REPORT

Marcelo Tunnel Inspection - Lama

Barrick Exploraciones Argentinas S. A., Proyecto Pascua Lama

March 20, 2018

Figure 1: Plug design - shape and size (after BEASA12210-2211-C-DW-0013-11)

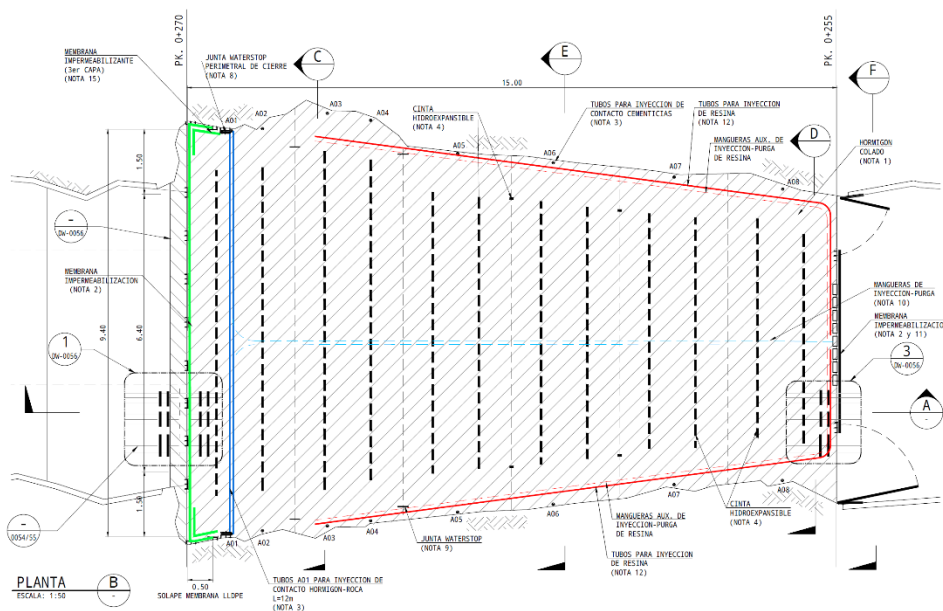
The tunnel was enlarged in the upstream side of the plug and tapered towards the downstream side. This wedge shape for the plug guarantees that there is a good mechanical contact between the concrete and the rock, without the need to rely solely on the frictional resistance of the interface (see Figure 1).

The preparation of the plug area in terms of temporary support and permeability control was adequate. The design and construction of the plug meet the requirements to hold the head of water upstream of the plug. The geometry of the plug ensures that it will be mechanically stable over the long term.

Figure 2: Layout of grouting holes (after BEASA12210-2211-C-DW-0059-6)

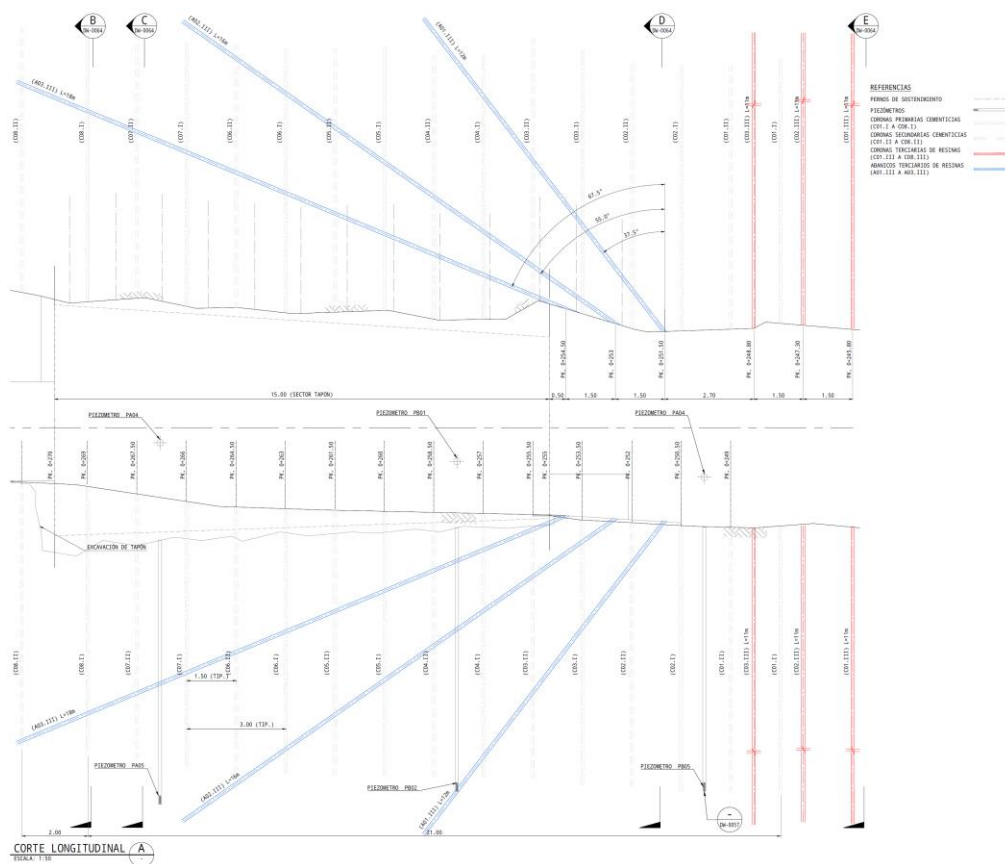
After the construction of the plug, a series of angled holes were drilled for the purpose of resin grouting the plug section, and an additional set of radial holes on the downstream side of the plug also for resin grouting (see Figure 2).

Figure 3: Location of piezometers (after BEASA12210-2211-J-DW-0057-3)

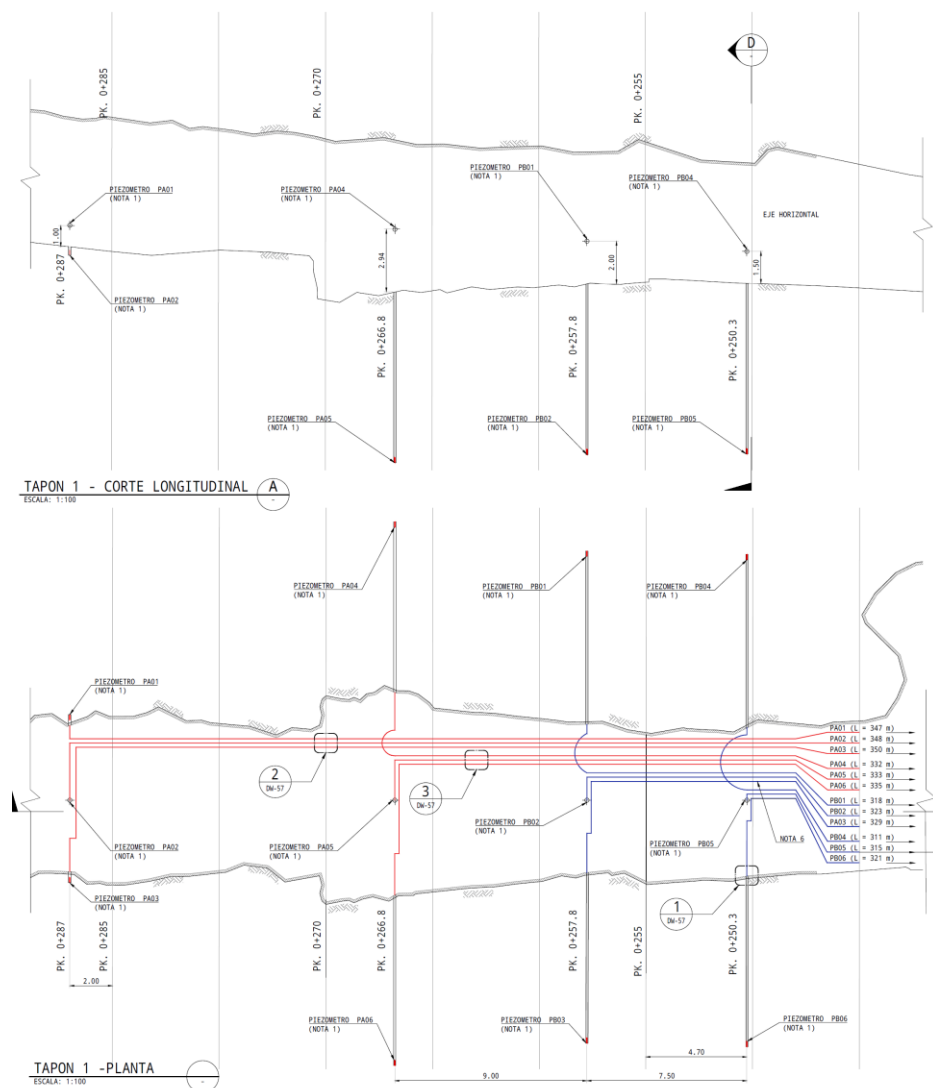
A series of piezometers were installed at 4 sections of the tunnel. Three piezometers were installed at each section (2 on the sidewalls, 1 in the floor). One section is upstream of the plug and the piezometers are installed close to the tunnel walls and floor. In the other 3 sections the piezometers were installed 8 m deep into the rock. Two of these sections are within the plug section and the other section is on the downstream side of the plug (see Figure 3).

Figure 4: Pressure head history for the piezometers (including the upstream array)

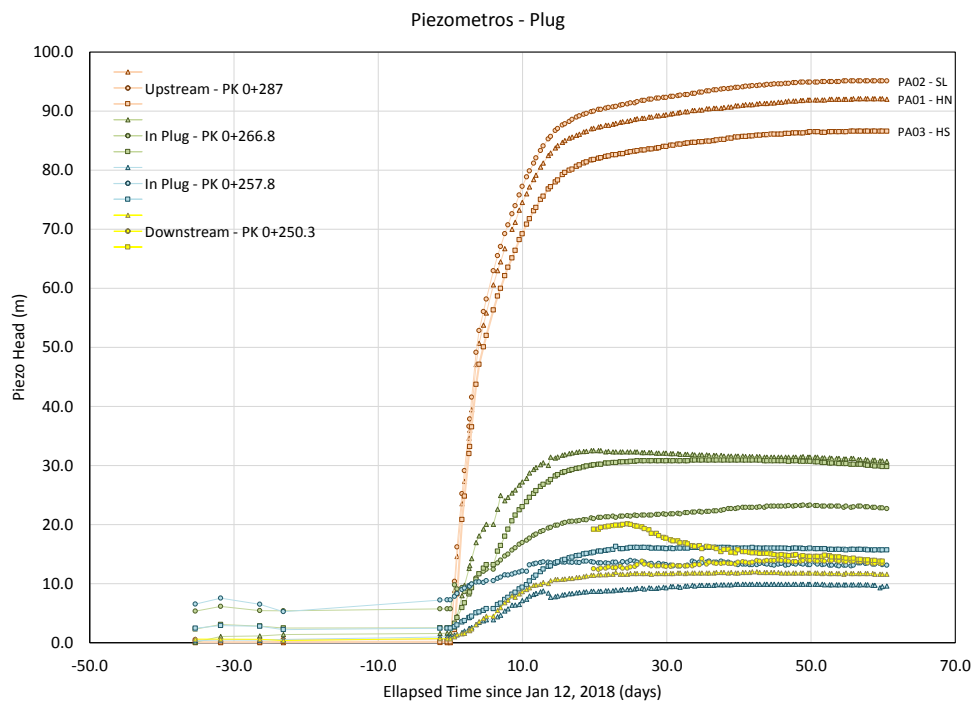
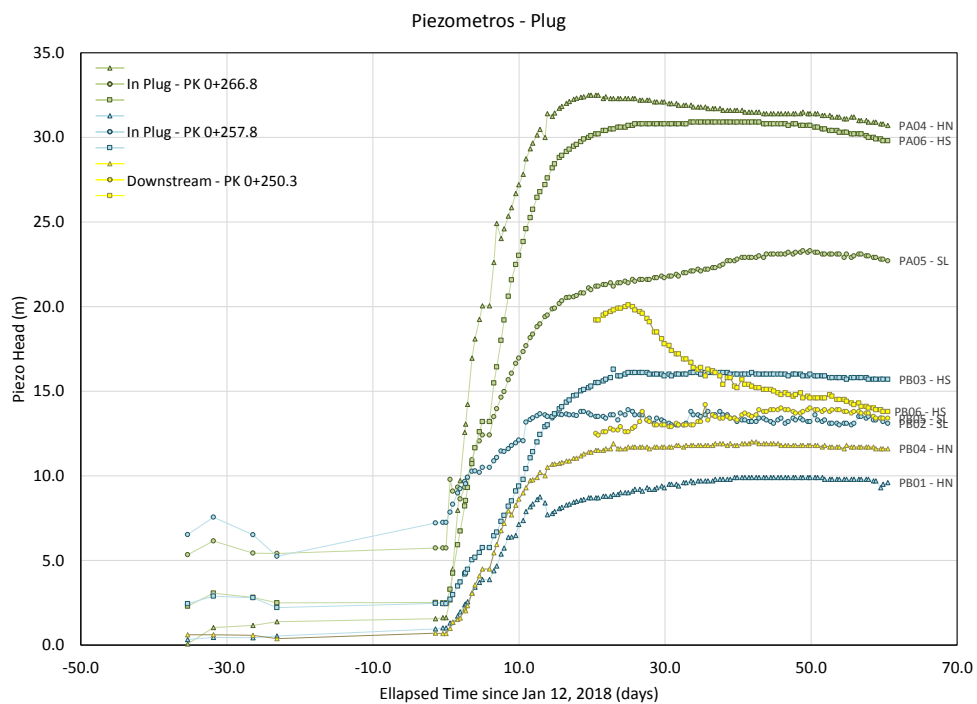
Figure 4 and Figure 5 show the time history of the pressure head in the piezometers. It took about 20 days to reach 95% of the full head, and 60 days after completion of the plug, the pressure head has stabilized on all piezometers. The pressure head on the downstream of the plug is between 10 and 15 m, with the higher head on the south sidewall. Figure 6 shows the flowrate history as a result of seepage through the rock around the plug. The flow rate reduced dramatically from 137 L/s to 2.5 L/s at the completion of the plug, and 60 days after completion it seems to be reaching a steady state flowrate of about 8 L/s. After the planned contact grouting is completed, it is expected that the flowrates will reduce further.

Figure 7: Pressure head profile in the rock around the plug

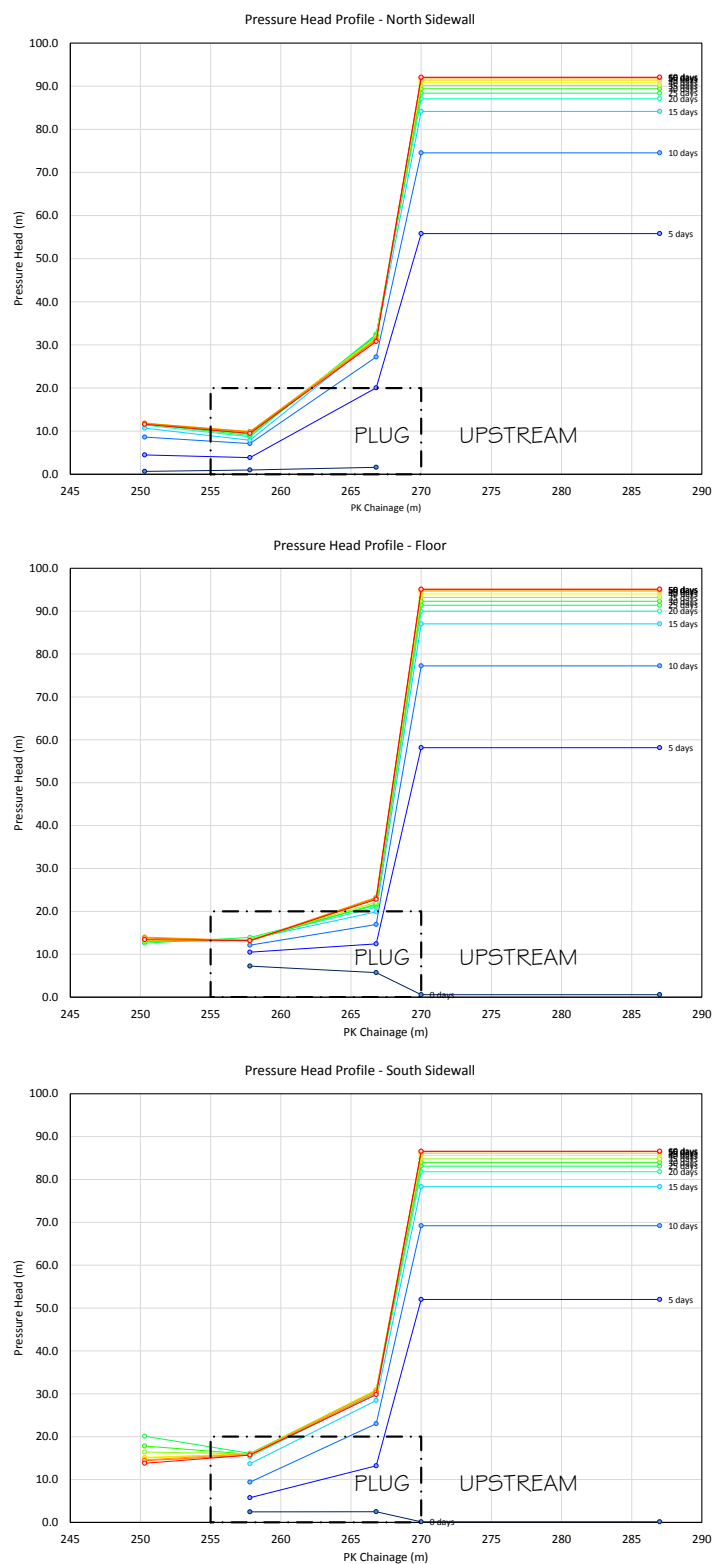
Figure 7 shows the pressure head profiles across the plug for the piezometers in the sidewalls and the floor. The average pressure head on the upstream side of the plug near the sidewalls and the floor is about 91 m. The pressure head drops across the plug to about 28 m at PK 0+266.8, and to about 13 m at PK 0+257.8. At the downstream array (PK 0+250.3) the average head is 13 m.
